JRPP No:	2009NTH012
DA No:	DA 2009/0443
PROPOSED DEVELOPMENT:	5 Storey Health Services Facility, Refreshment Room and Basement Carpark - 21 Gore Street, Port Macquarie
APPLICANT:	Chris Jenkins Design Architect Pty Ltd
REPORT BY:	Ben Roberts Development Assessment Planner, Port Macquarie-Hastings Council

Assessment Report and Recommendation

This report considers a development application for a 5 storey health services facility. Refreshment room and basement carpark at Lot 1 DP 758853, 21 Gore Street, Port Macquarie.

TITLE
**BASEMENT CARPARK
RL 6.30**

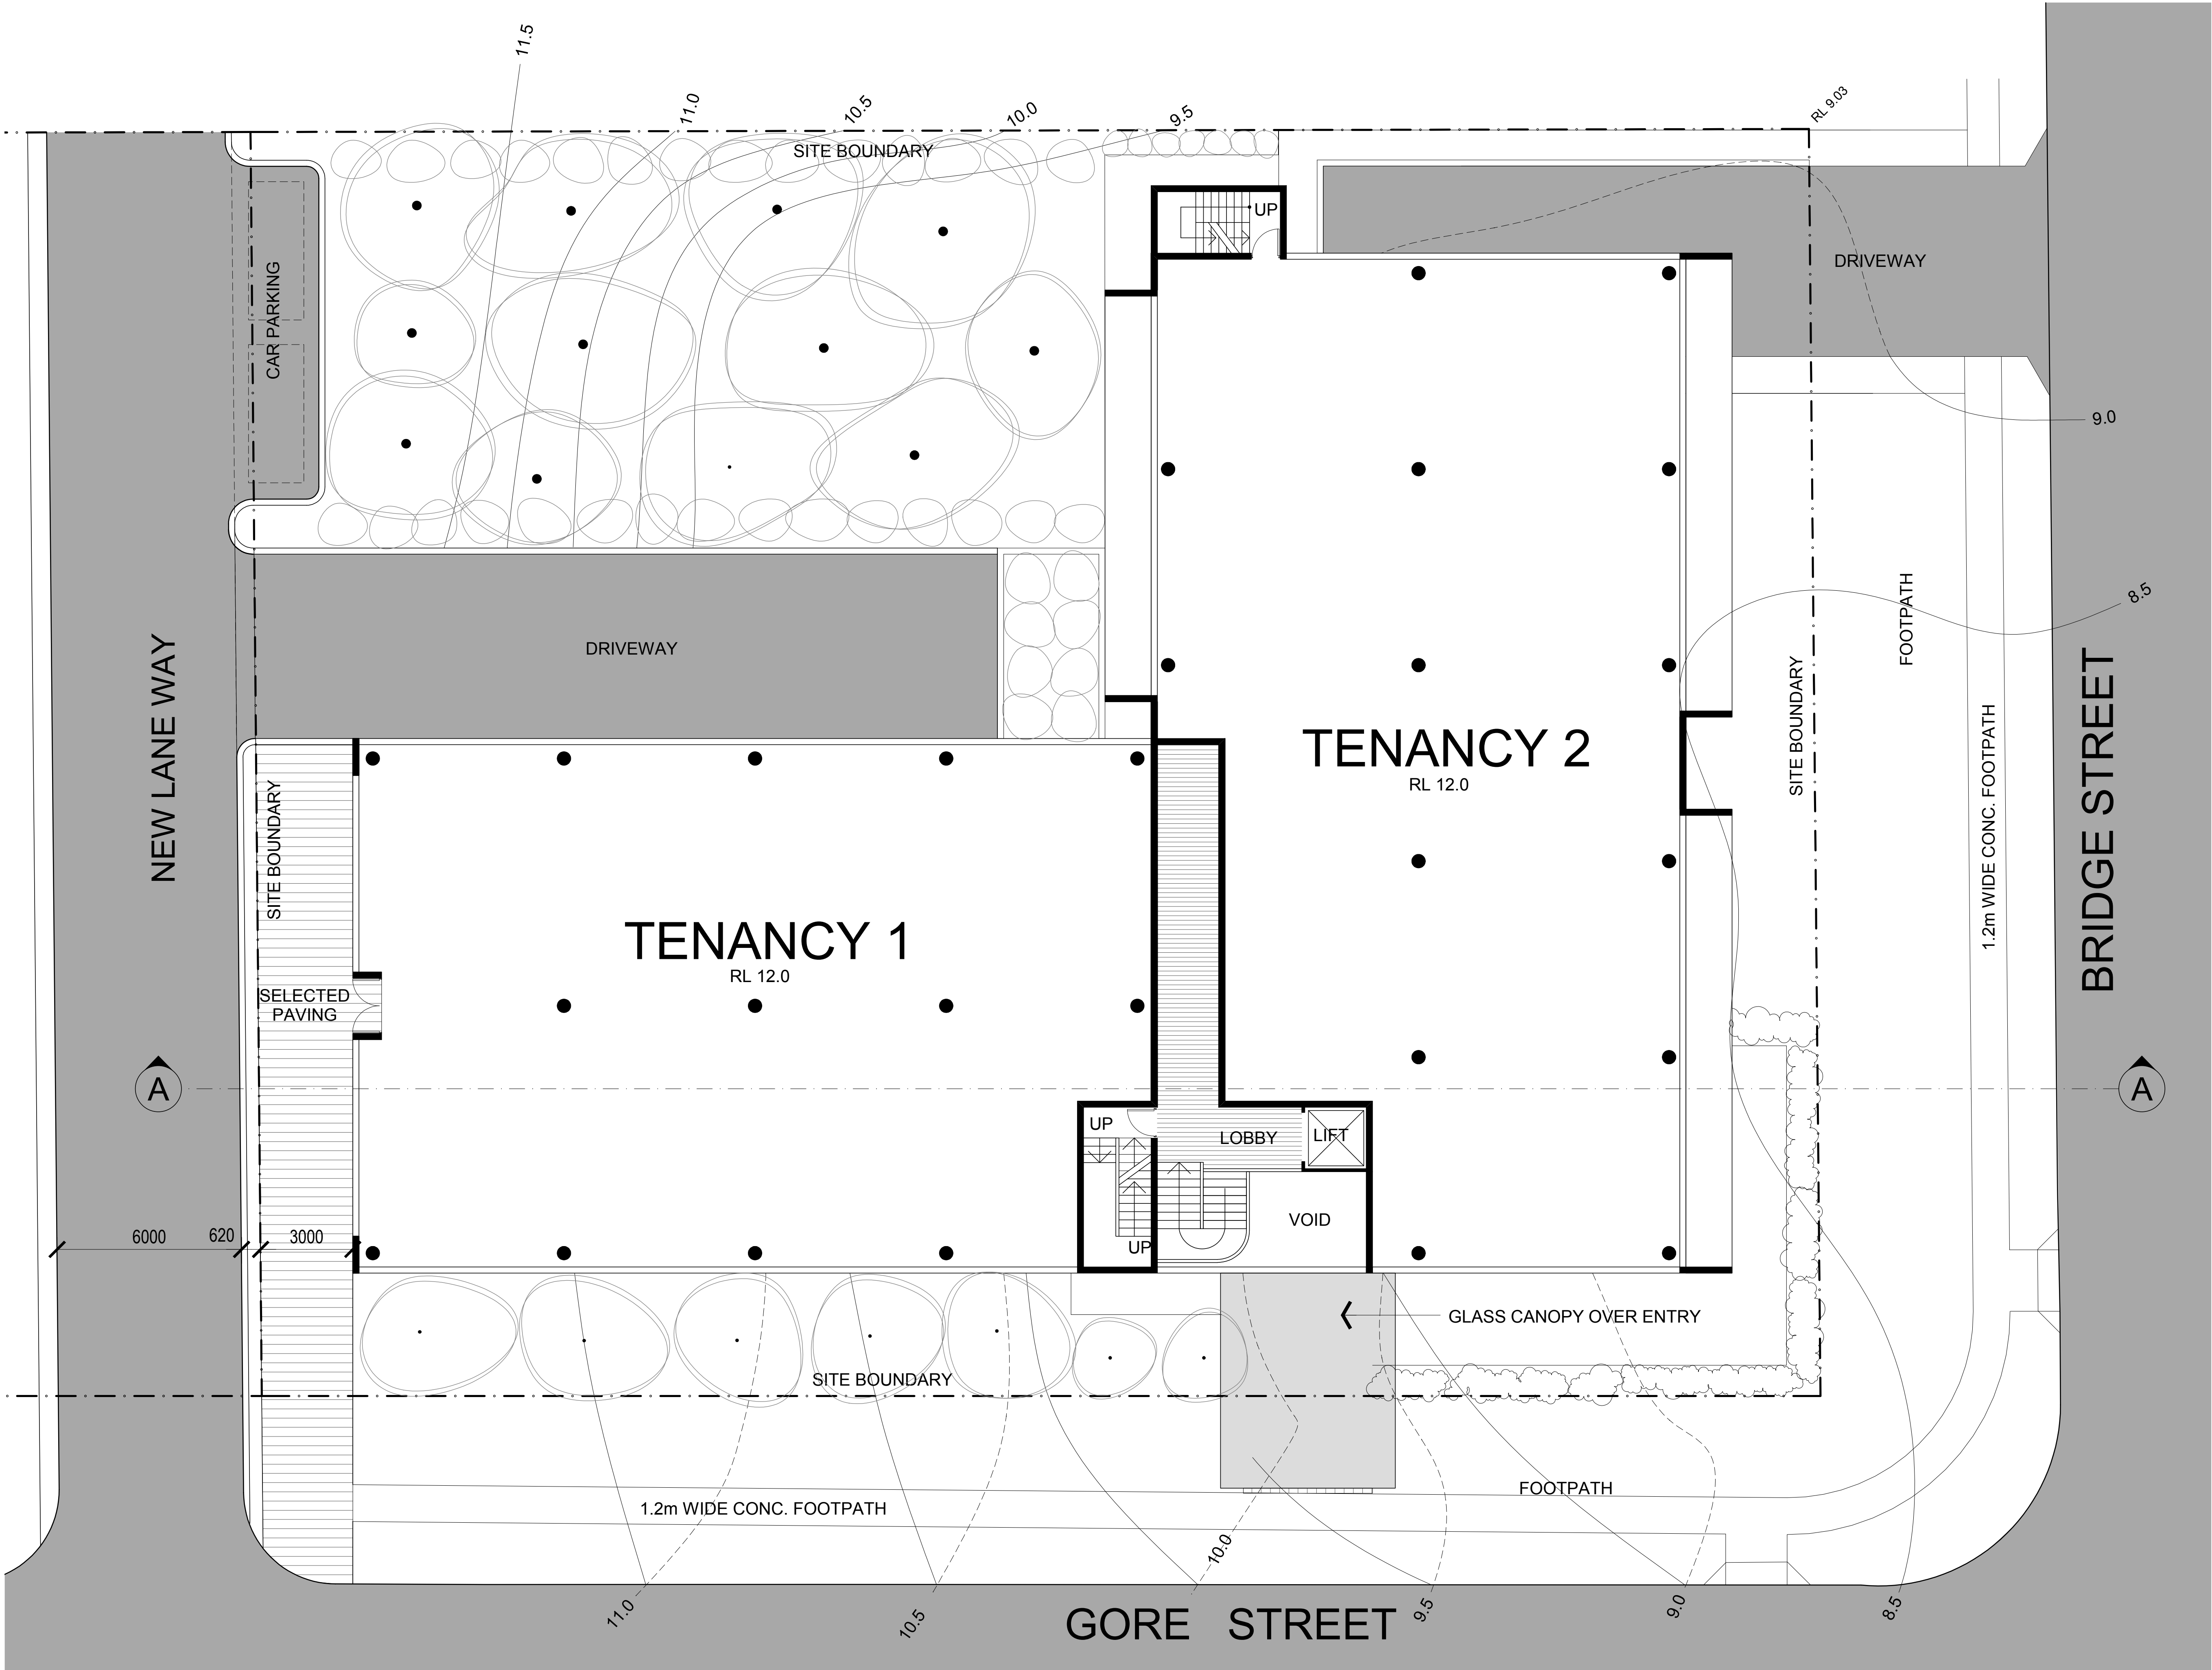
It is noted that no disabled spaces have been nominated. For medical centres the plan requires at least 3% of total spaces, or part there of, to be designated as disabled spaces. Accordingly, two (2) spaces are to be designated as disabled spaces in accordance with AS 2890.1:2004.

Column placement for the basement and ground floor car park does not comply with AS/NZS 2890.1. Parking or column placement should be revised to accommodate the standard parking envelope defined in AS/NZS 2890.1.

Sweep paths and manoeuvring templates need to be conducted into and out of both car park facilities to verify adequate turning radii for entering and exiting vehicles into and out of the car park facilities.
